**IMPACT
ASSESSMENT
STUDY
FOR
PROPOSED
DAWSON
DAM**

FEBRUARY 1998

**SUPPLEMENTARY
REPORT**

Agricultural Suitability

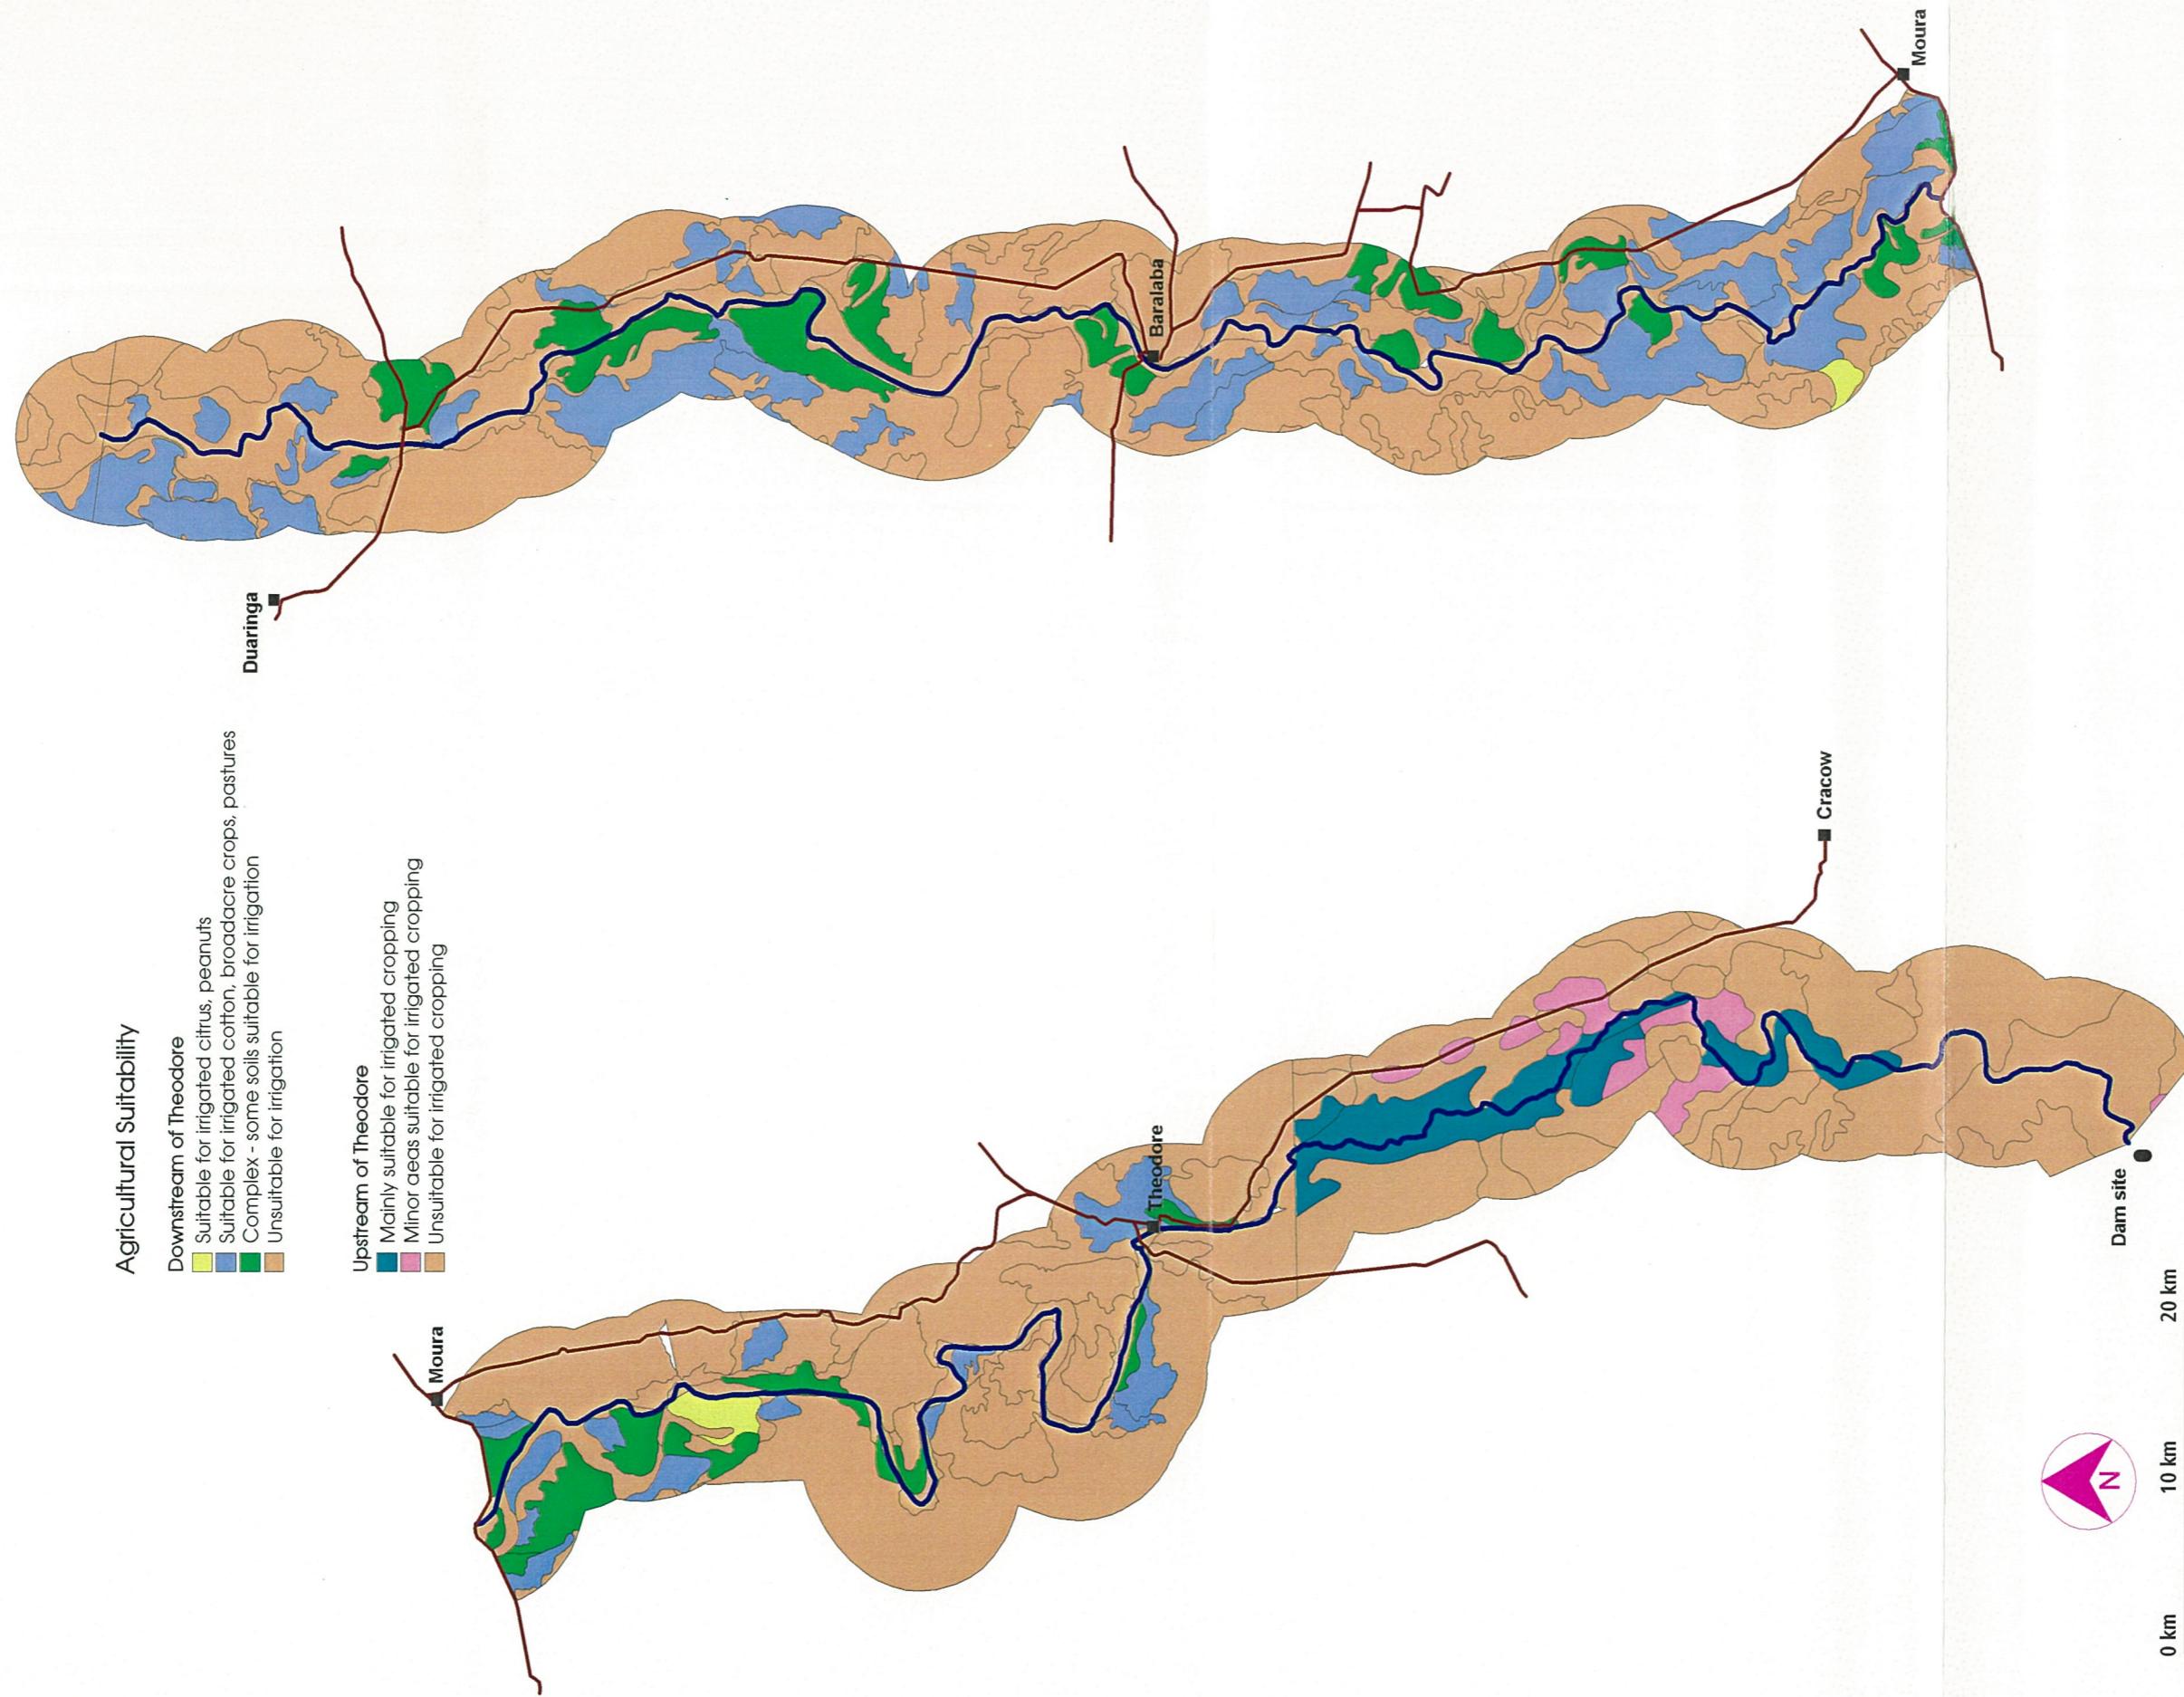
One submission questioned the missing section of agricultural suitability data between the dam and Theodore. The attached Map replaces Map 14 in the main report.
